**DRB RECOMMENDATION PACKAGE**

## PUBLIC STORAGE

1200 SOUTH DEARBORN STREET, SEATTLE, WA

**DPD PROJECT #:** 3017092

ROOF PLAN

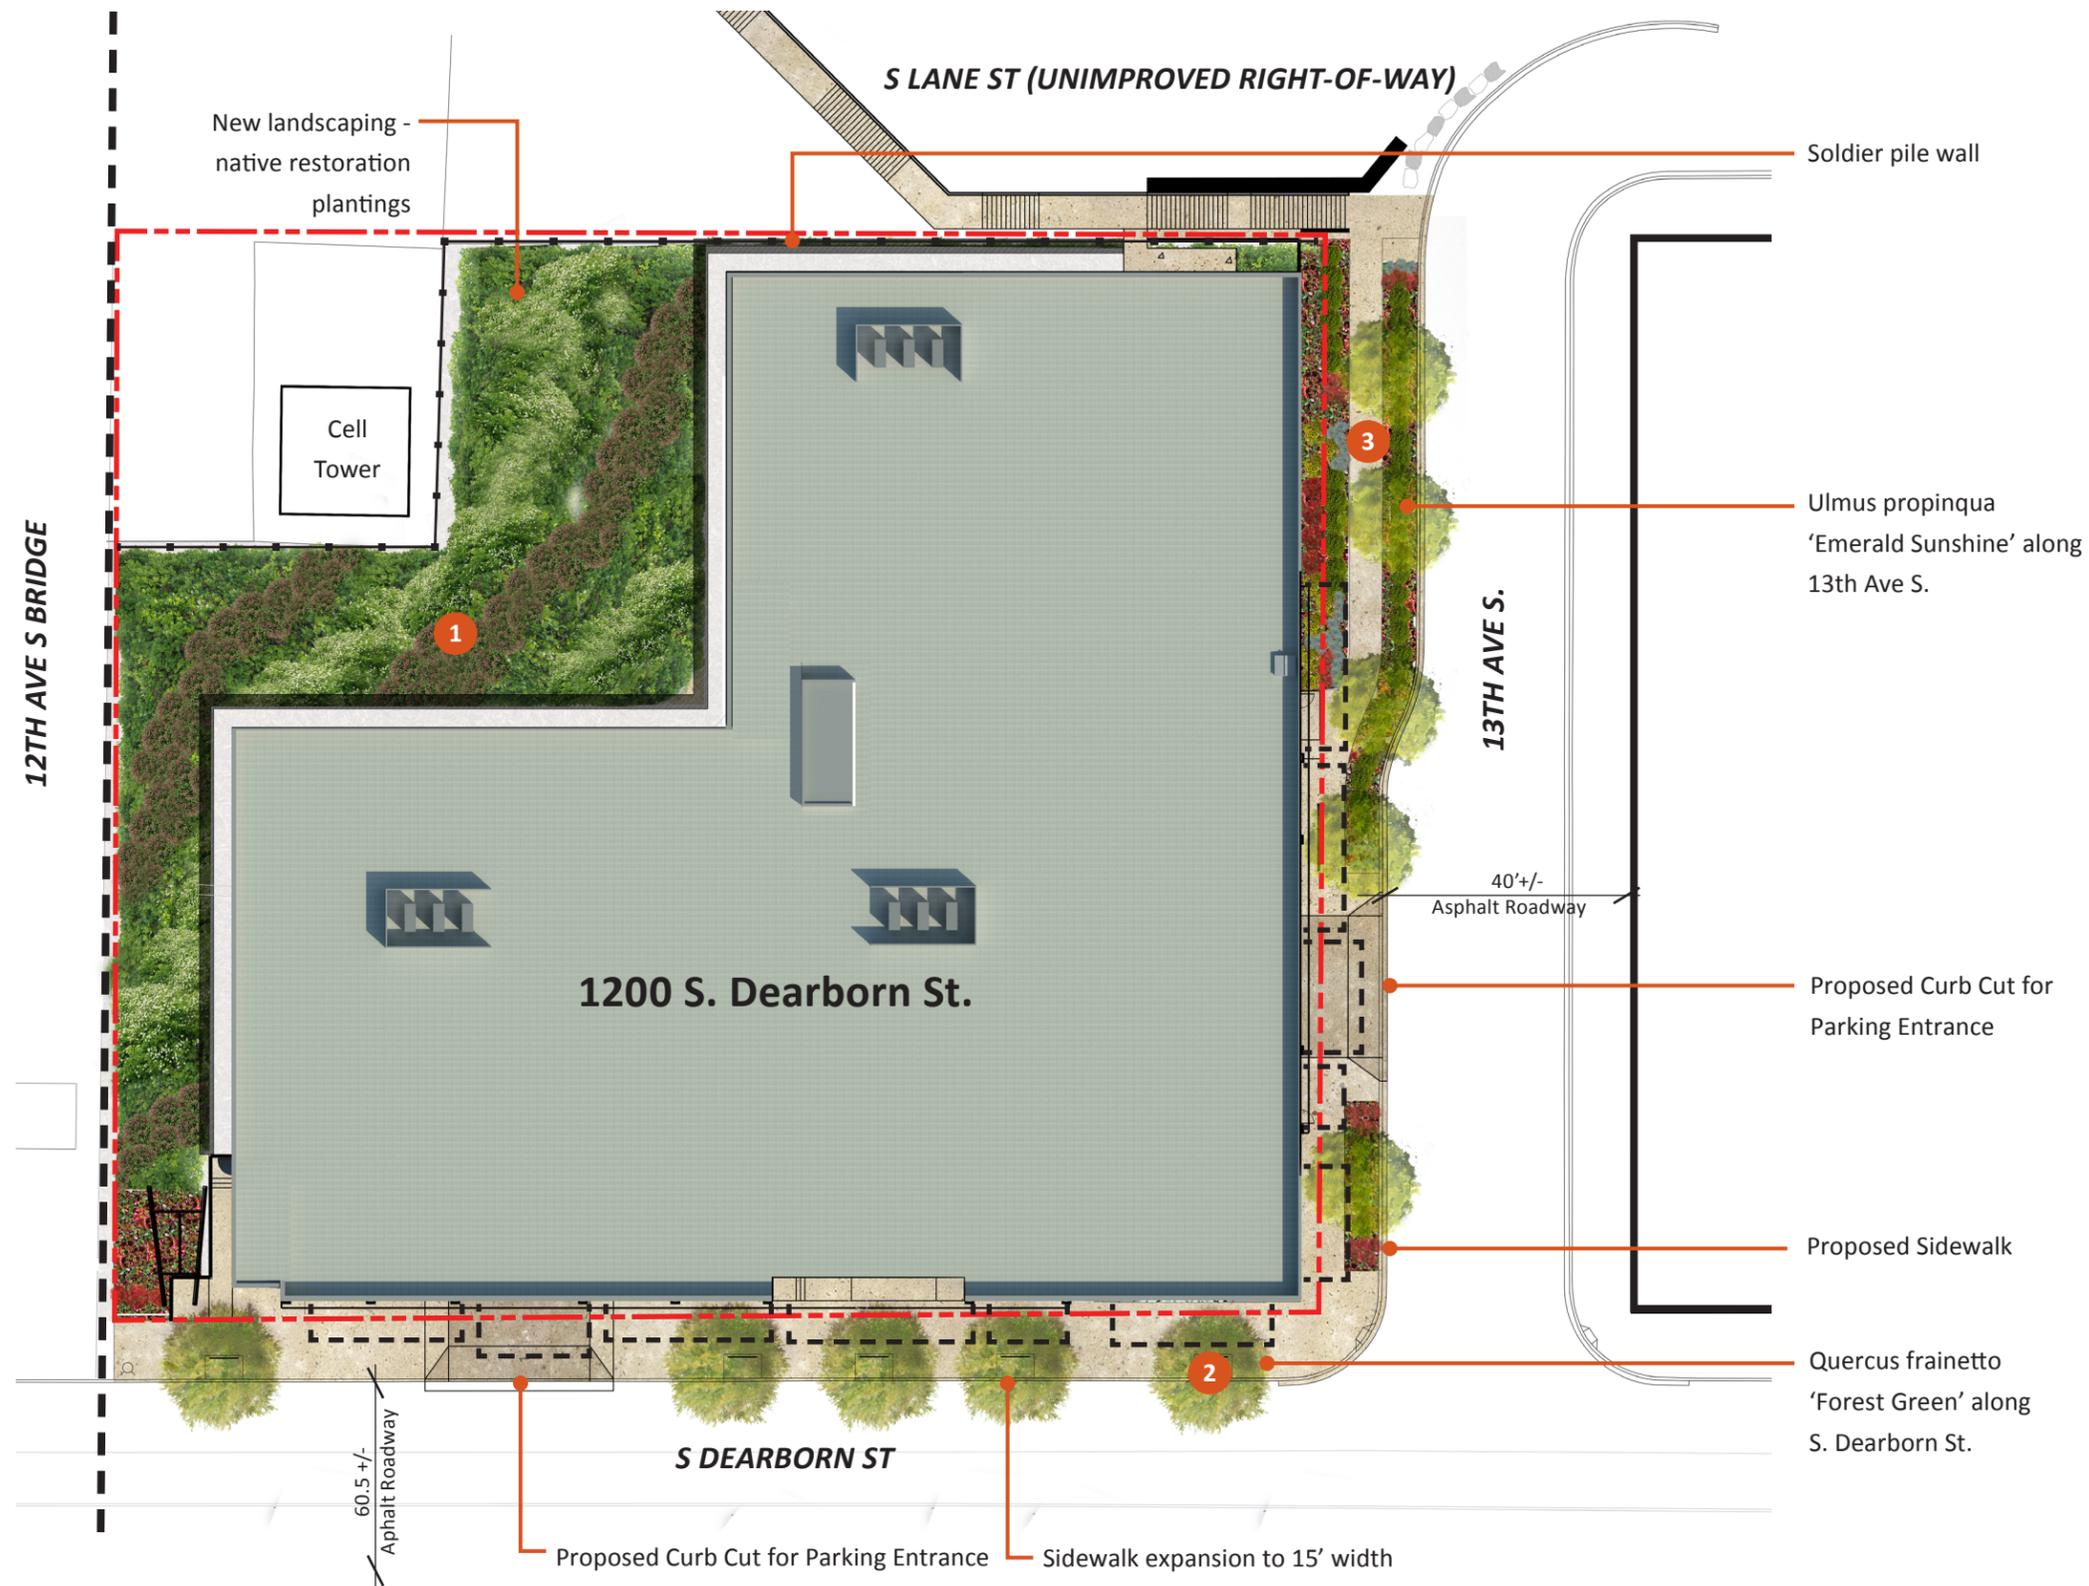
**July 22, 2014: The Board appreciated the additional information supplied by the applicant, and discussed the importance of the treatment of the roof. The Board suggested screening or other treatment, and requested further refinement of the roof. The Board asked that a roof plan be presented at the Recommendation Meeting. Perspectives from the 12th Avenue South Bridge, and access to/from the roof shall also be presented.**

[BCRA Response: Roof top units will be screened from view with enclosures constructed with similar materials as those found elsewhere on the building. A roof plan has been included and can be found on page 22. Perspectives from the 12th Ave South Bridge have been included and can be found on pages 30 and 31. Access to and from the roof will be via a roof hatch. Because the roof is a non-occupied space and the roof does not include elevator equipment extending, a stair tower is not required.](#)

SECTION AT BRIDGE PROPOSED BUILDING-FACING EAST

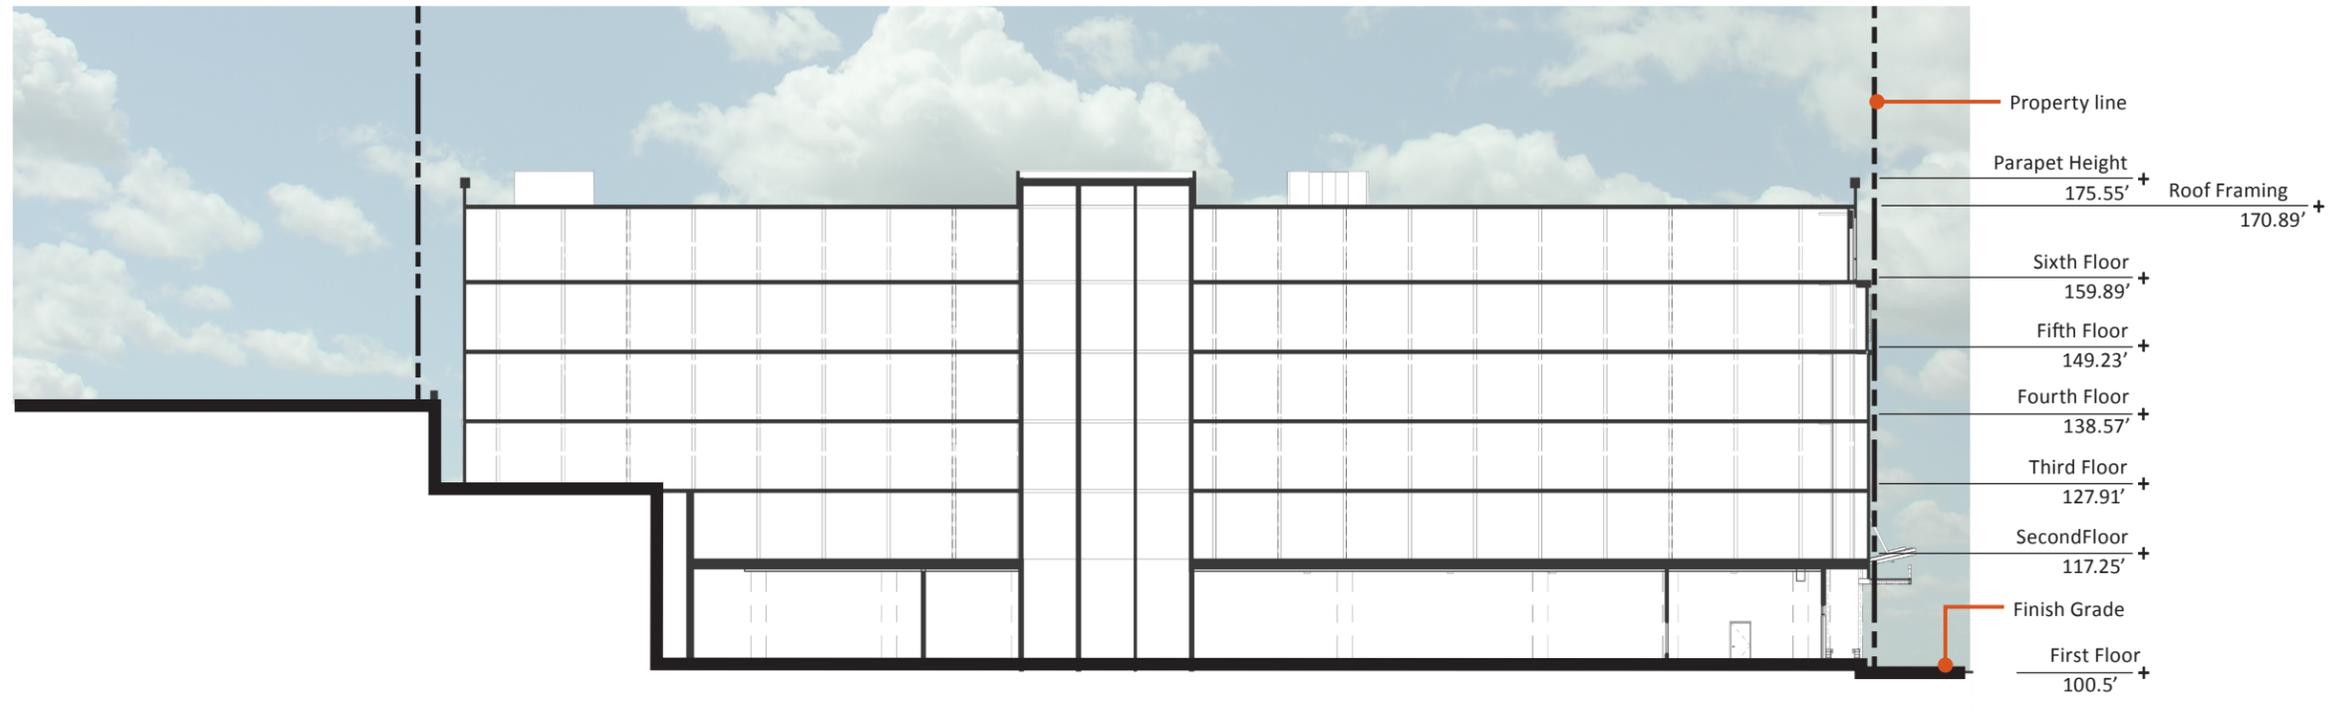
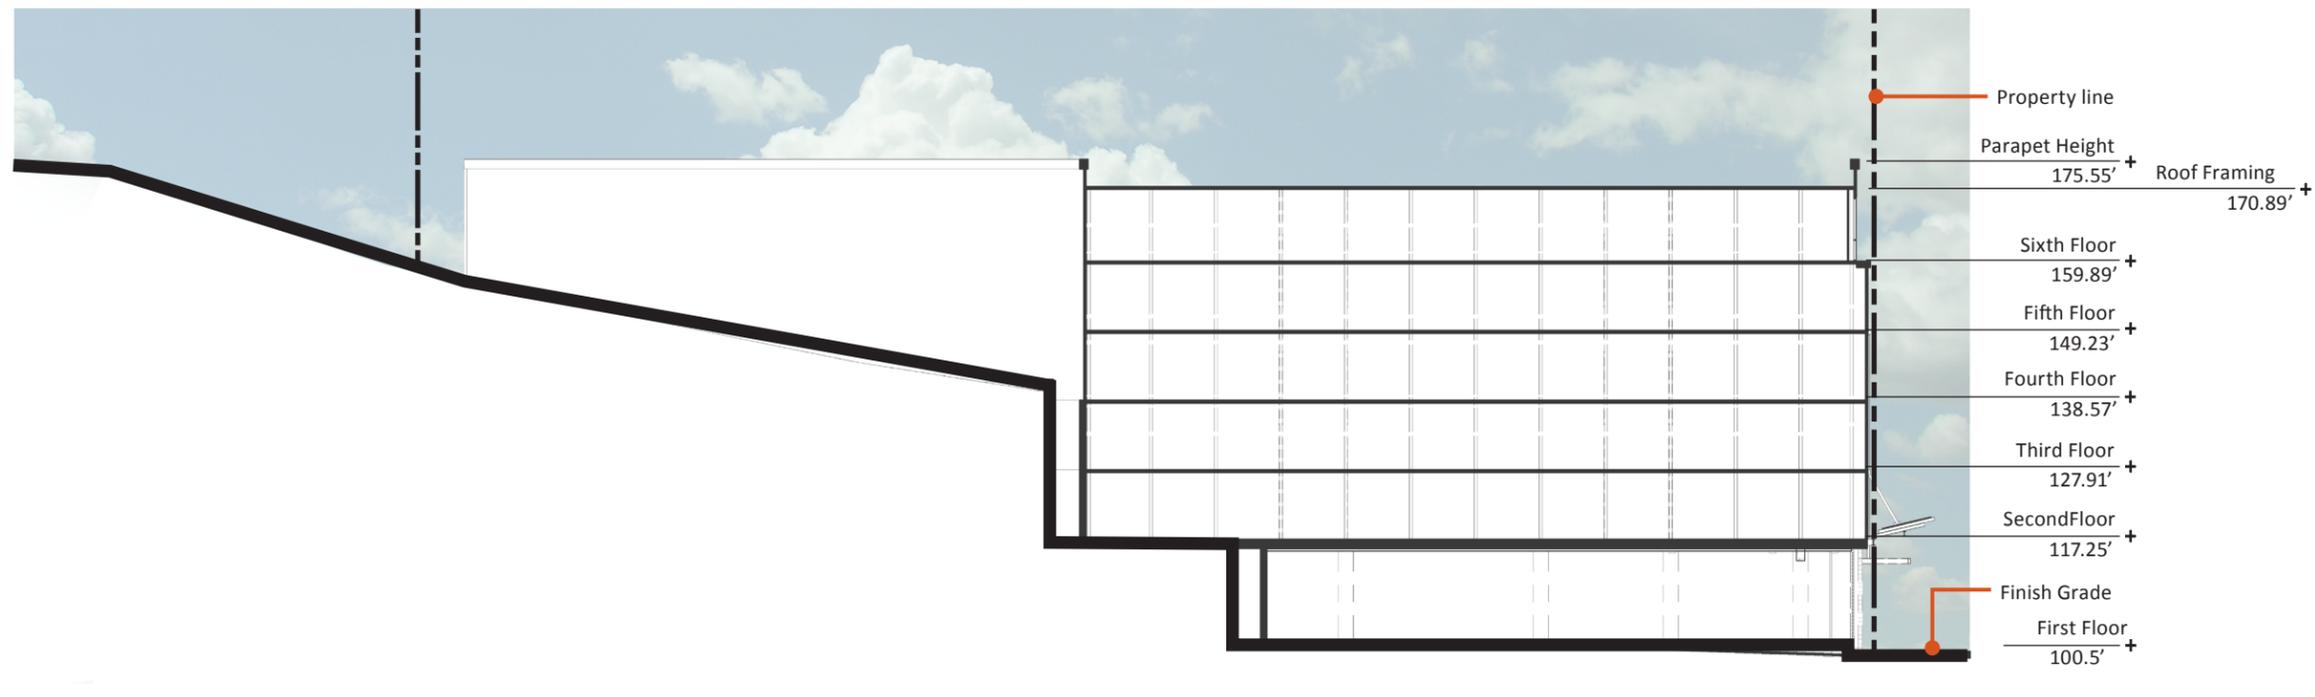
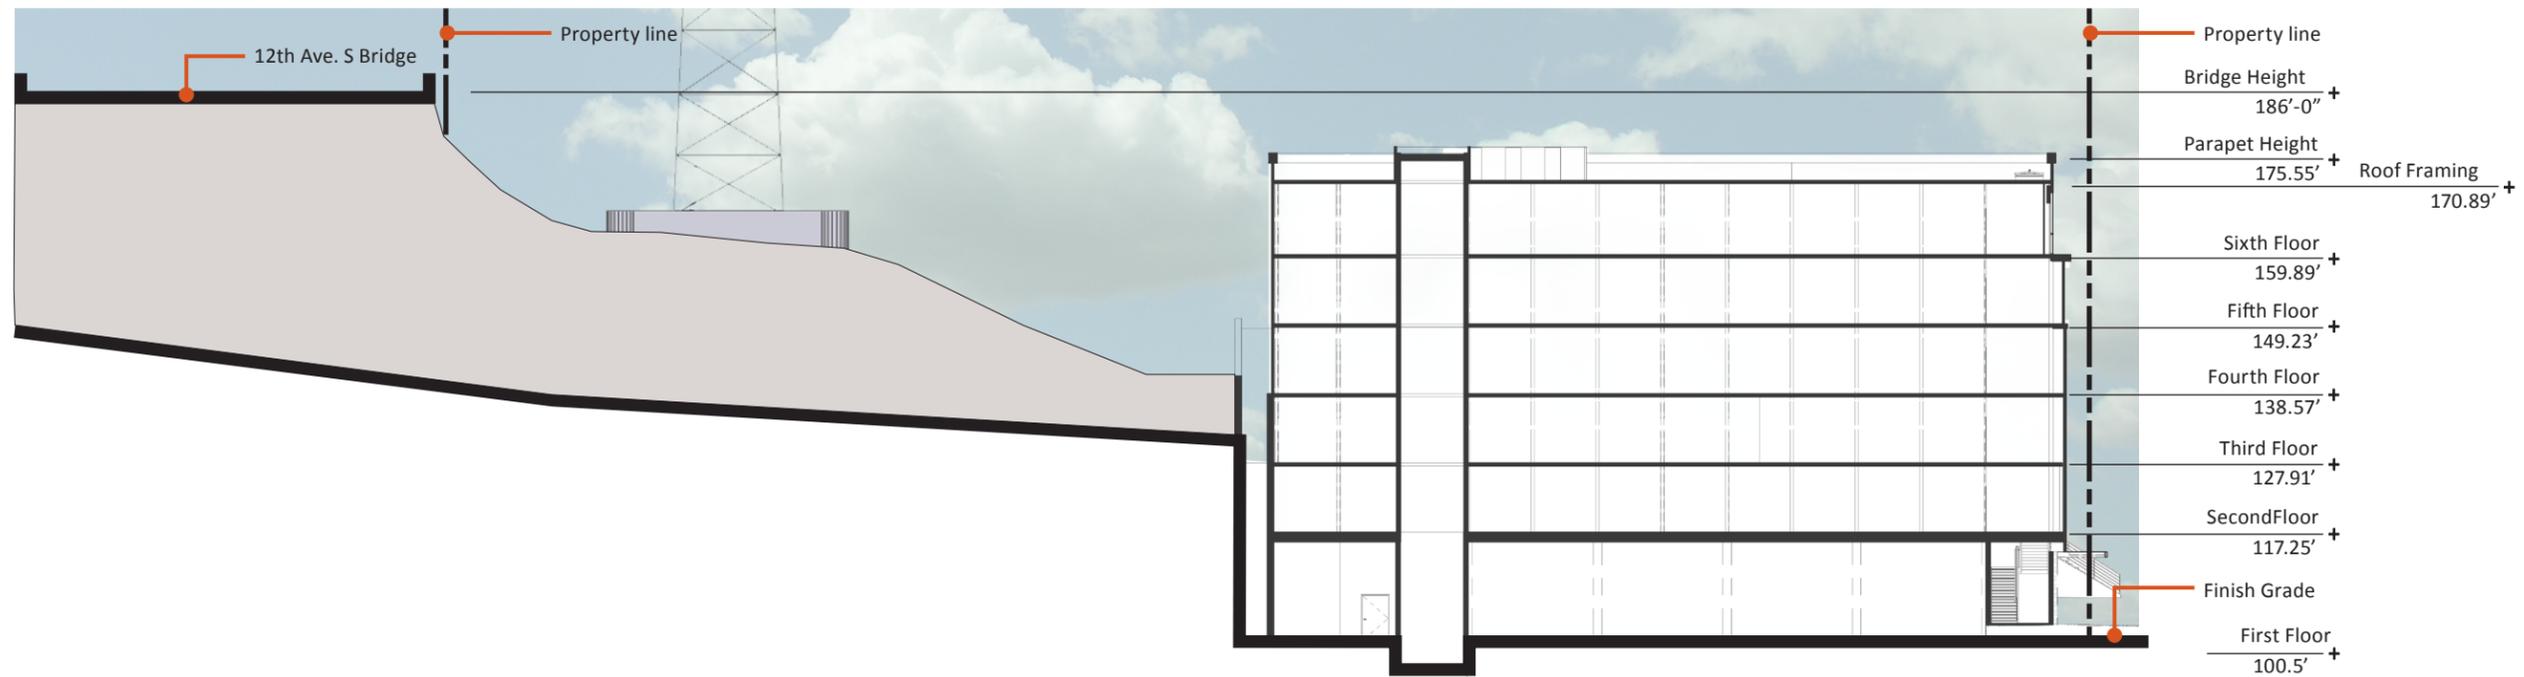
**June 10, 2014: The Board noted that the adjacent 12th Avenue South Bridge to the west provides a prominent presence in the area, and recommended the project further respond to the height, bulk, and scale of adjacent development. The Board requested to see section drawing illustrating the relationship of the building to the 12th Avenue South Bridge at the Second Early Design Guidance Meeting.**

**July 22, 2014: The Board reviewed the context analysis of the bridge and structure (page 31), and agreed that the size of the structure in keeping with the neighborhood context of existing structures and projected future development to the west. The Board requested that the following be presented at the Recommendation Meeting: a north-south drawing of the west wing of the structure, including the adjacent communication utility tower.**

*BCRA Response: The proposed building will be approximately 10 feet below the 12th Ave. Bridge deck and is set back approximately 25 feet from the bridge structure, as shown in the site section on page 36*

BCRA Response: A building section through the west wing showing the existing communication tower is shown on page 36.
